**CITY OF MERIDIAN
FINDINGS OF FACT, CONCLUSIONS OF LAW
AND DECISION & ORDER**

Case No(s). H-2020-0092

STAFF REPORT
COMMUNITY DEVELOPMENT DEPARTMENT

SUBJECT: H-2020-0092
 Goddard Creek Community

B. Preliminary Plat (date: 9/2/2020)

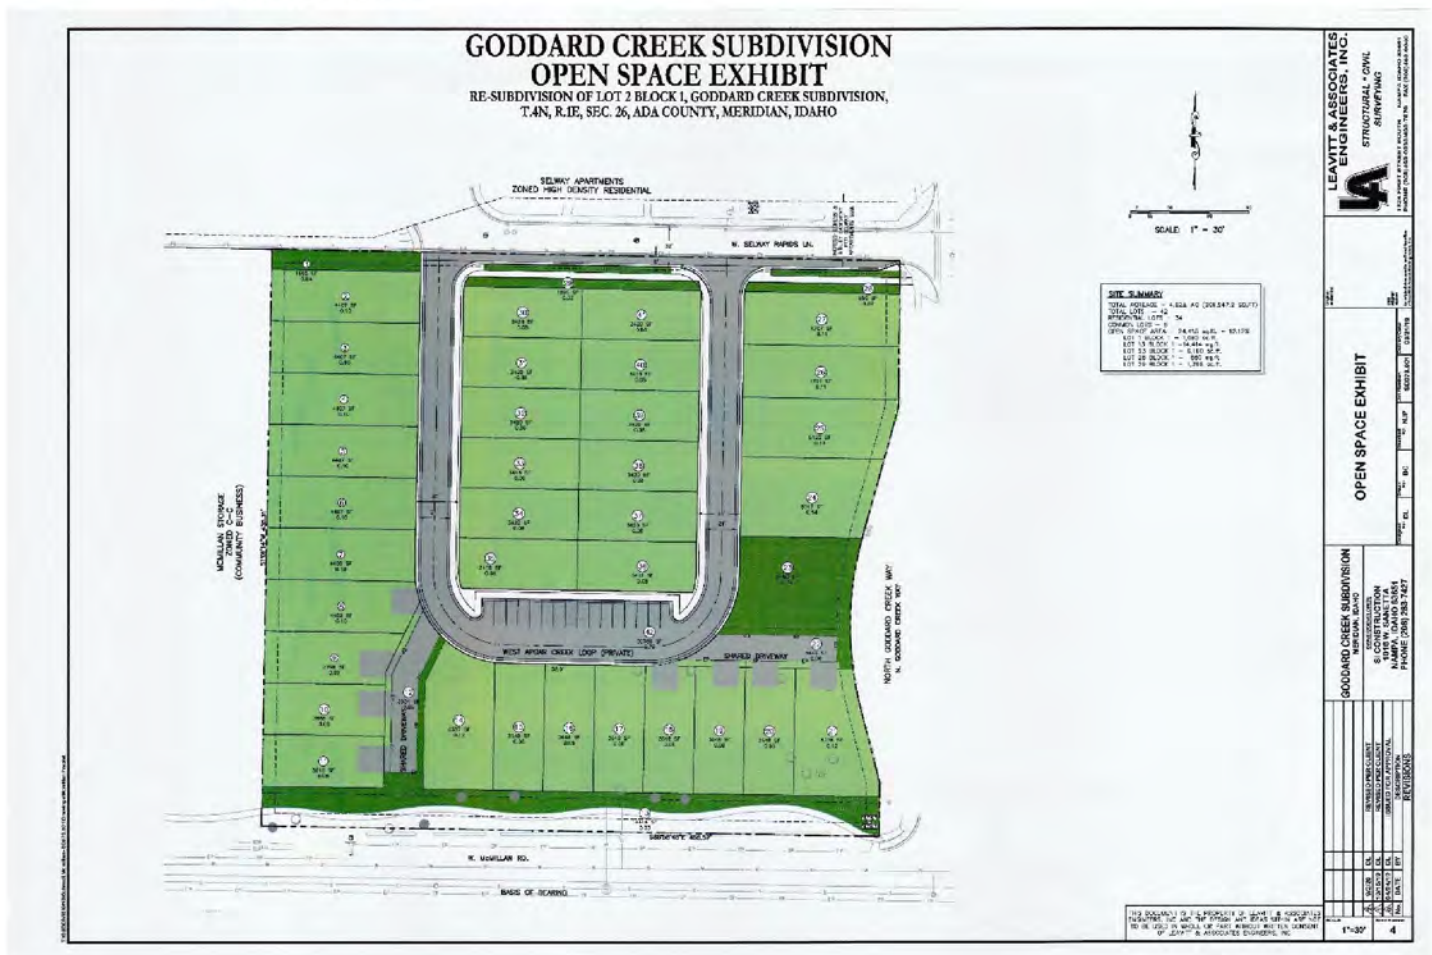
- b. The Applicant shall widen W. Apgar Creek Lane (the existing private street abutting the subject site) by eight (8) feet in order to accommodate on-street parking along the southern side of the street as shown in the proposed preliminary plat (Exhibit VII.B).

- c. Any area of the plat where pedestrians need to cross the private street for added pedestrian connectivity shall be constructed with pavers, stamped concrete, or similar in order to clearly delineate the pedestrian pathways from the driving lane; this includes the proposed pedestrian connection that runs next to the southwest common drive (Lot 12) that connects to W. McMillan Road.

- c. Add a sidewalk connection within Lot 1 that continues the sidewalk on the west side of N. Selway Falls Lane.
 - d. Show all pedestrian crossings as pavers, stamped concrete, or similar to clearly delineate pedestrian connections and provide Staff a pedestrian exhibit that shows this and shows a cross-section of the crosswalks.

EXTERIOR ELEVATIONS
A4.0

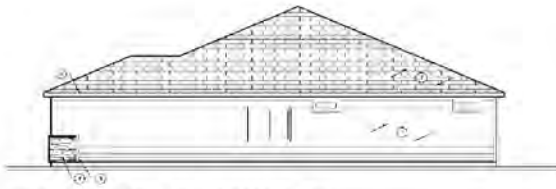
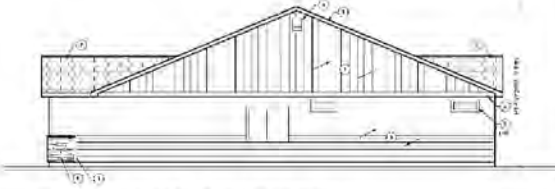
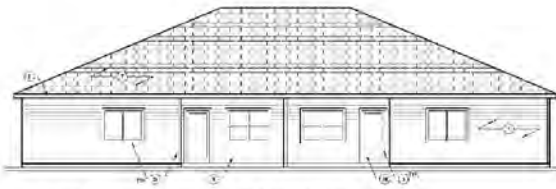
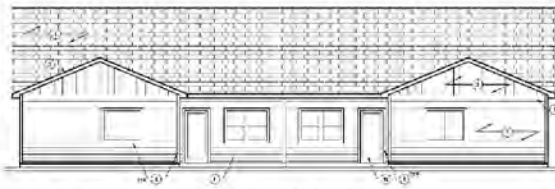
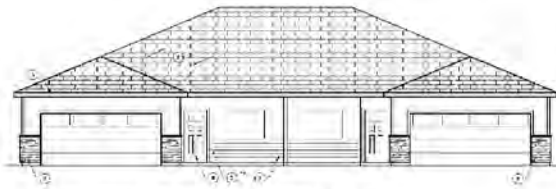
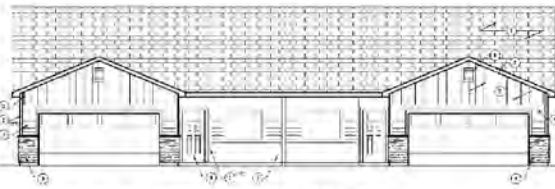
The design of structures on this site is required to comply with the design standards listed in UDC 11-3A-19 and the City of Meridian Architectural Standards Manual because they are an attached product with two or more dwelling units. The development should incorporate high quality architectural design and materials that is also consistent with the MU-C designation. Conceptual building elevations are proposed as shown for the single-family attached units.

- a. Parking issues that persist within adjacent apartment complex;
- b. Concern over the proposed elevations that face towards the public right-of-way.

- a. Future development of this site shall comply with the preliminary plat, landscape plan, and conceptual building elevations (single-story) included in Section VII and the provisions contained herein.

F. Public Works – Water Markup

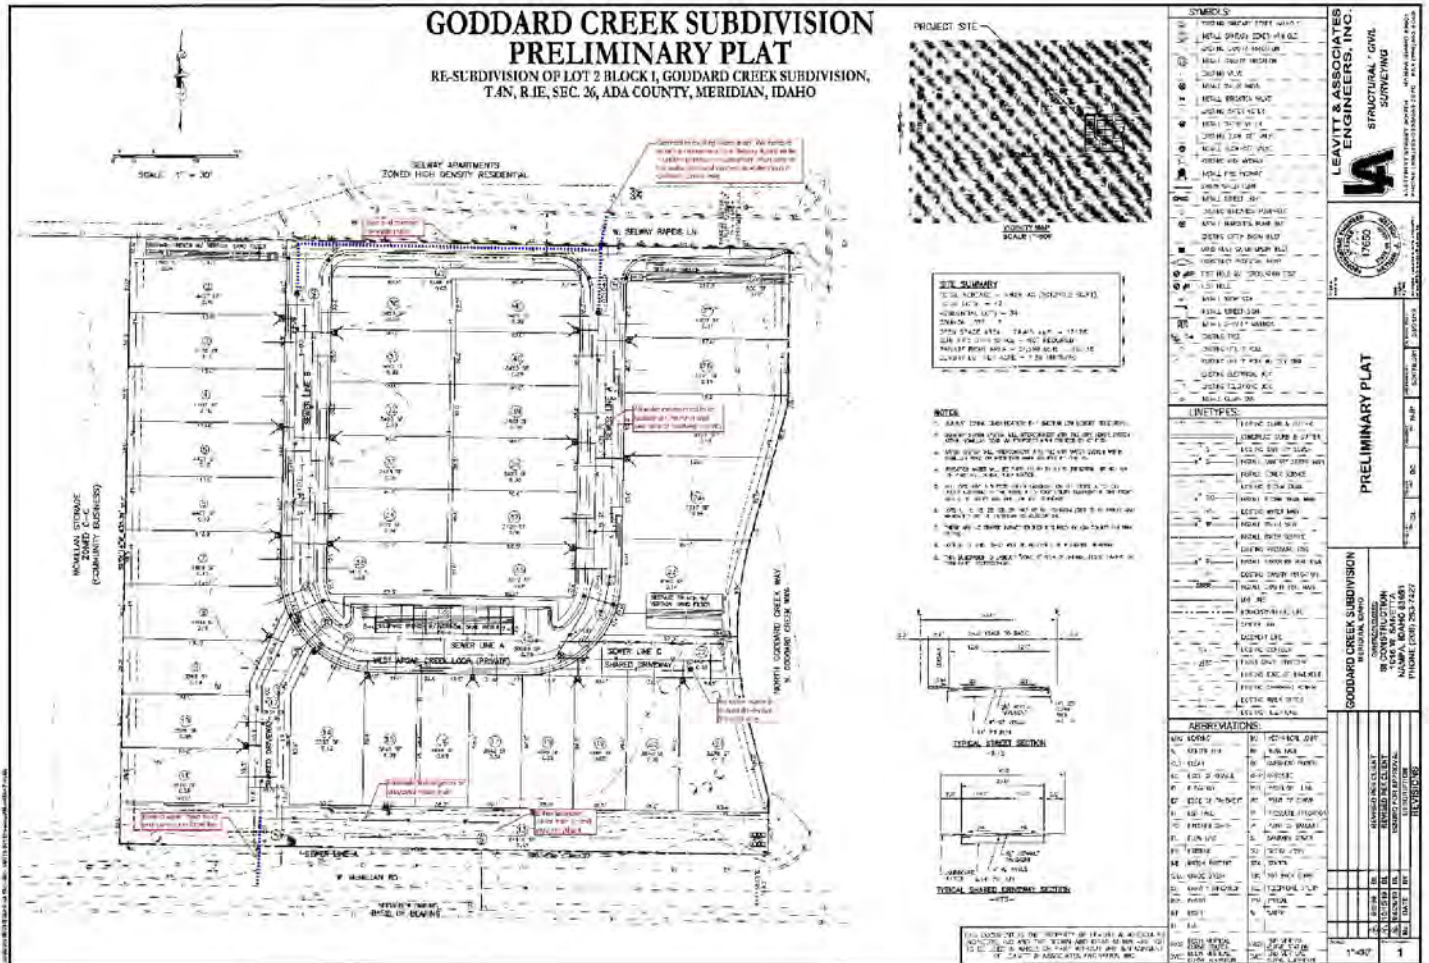
One issue presented by Public Works is regarding the proposed sewer and water mains shown in the common drive in the southeast corner; Public works requires that if the common drive serves three (3) or less properties that only service lines should be constructed and not mains.

The main issue is regarding the water line layout and a requirement to connect to the existing main within W. Apgar Creek Lane from both of the proposed stubs off of this road to create a looped system. The Applicant would need to obtain an easement from Selway Apartments to connect their existing main. In addition, Public Works is requesting that the Applicant change the connection point to the water main within McMillan Road to connect directly south of the emergency access instead of heading east within the landscape buffer.

1. Remove the water mainline from the shared driveway at the southeast, water services will need to be extended from the mainline.
2. Instead of connecting the water main to the southern stub, extend the water main south directly to McMillan to eliminate unnecessary parallel water main. The existing stub will either need to be abandoned or end in a hydrant.

5. Remove the sewer mainline from the eastern Shared driveway, and instead run individual services to serve the lots. Manholes are required at all mainline angle changes.
